**INDUSTRIAL DRIVE ATHLETIC FIELDS AND
DAWSON RECREATION IMPROVEMENTS
HOLDEN, MA**

ADDENDUM NO. 4

CONSTRUCTION DOCUMENTS

March 8, 2024

2 EXTERIOR GROUND SIGN - FRONT VIEW
1 1/2" = 1'-0"
1/A932

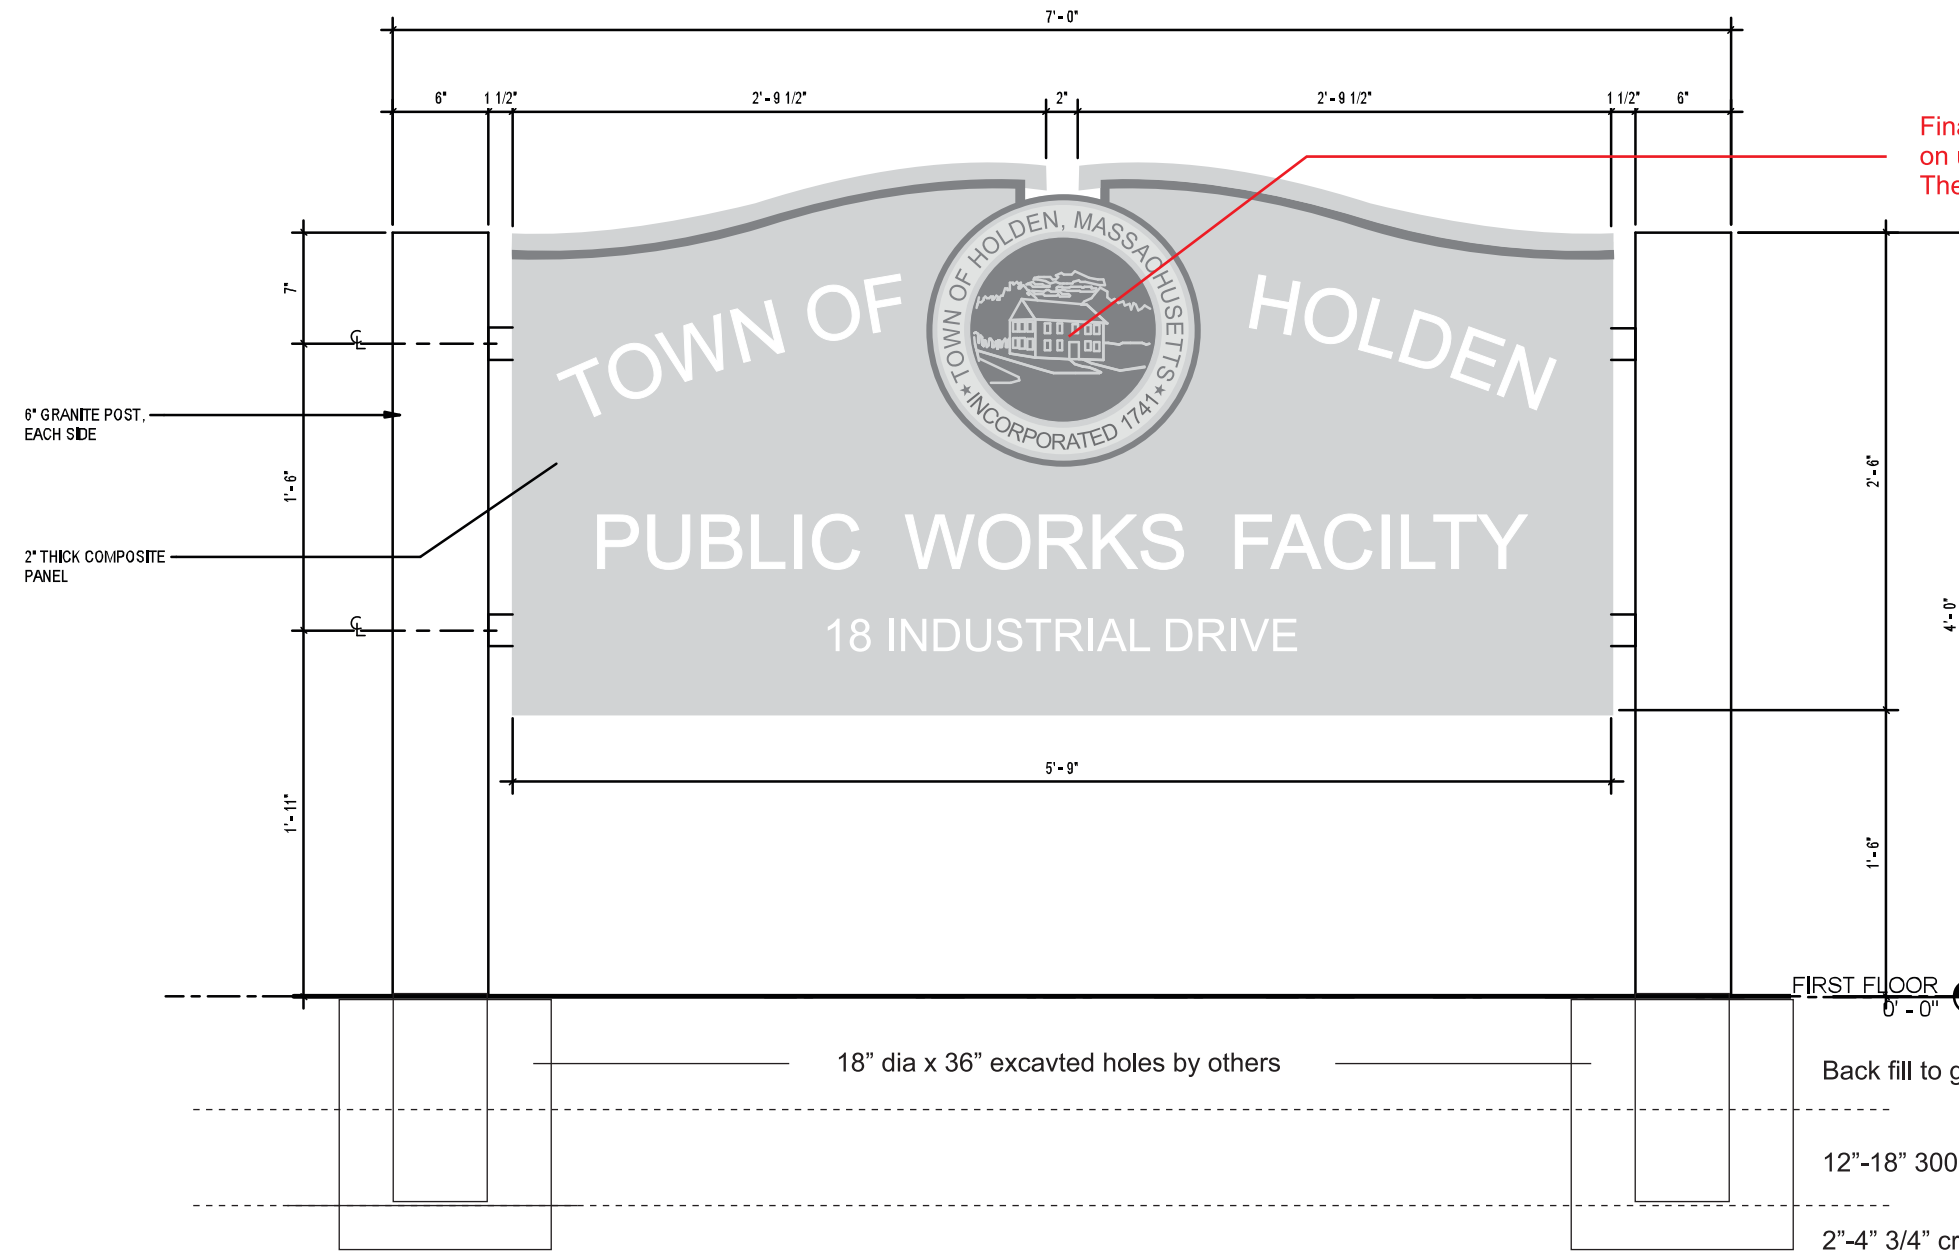
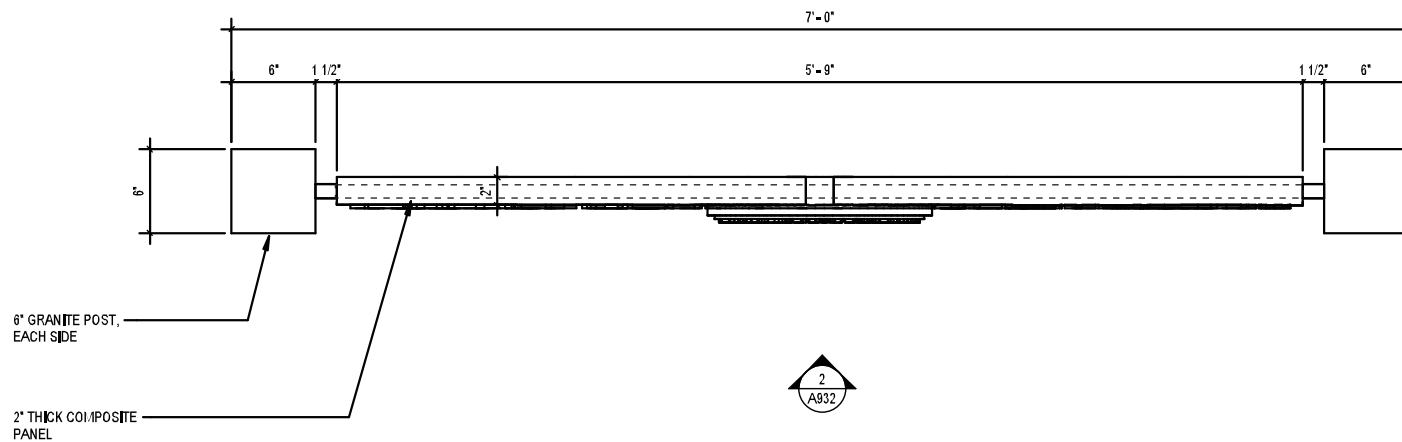
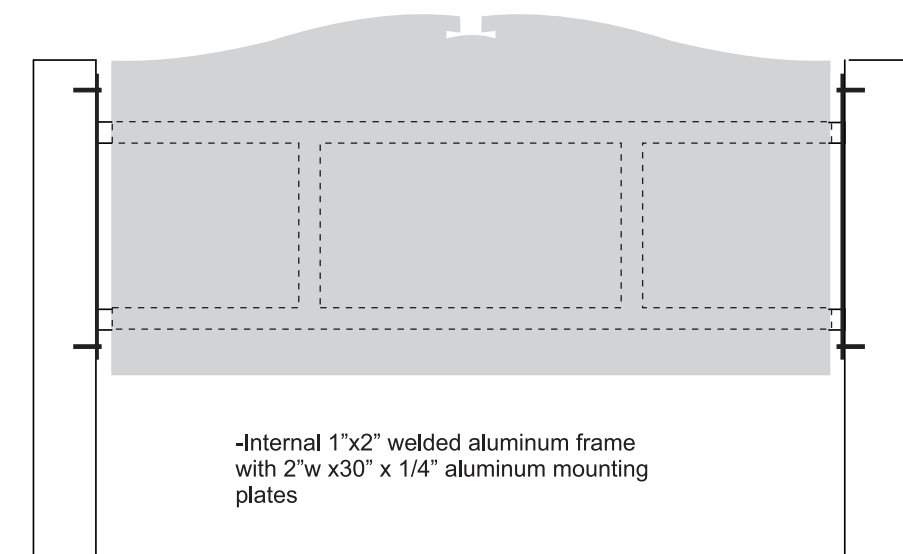
Question 10: *Is the monument/entry sign (5/L707) just a plain bulletin board or a panel with graphics as indicated in the specs?*

Question 42: *Is the Entry Sign shown on the inset of L300 and detail 5/L707 the same at the "Monument Sign" noted in specification section 32 17 23-3 2.04A? Can you provide more detail so this can be priced accurately?*

Response: For clarification, the entry sign shall be per attached cutsheet example from the Public Works Facility project.

Response: See clarification above and attached cutsheet example from the Public Works Facility project.
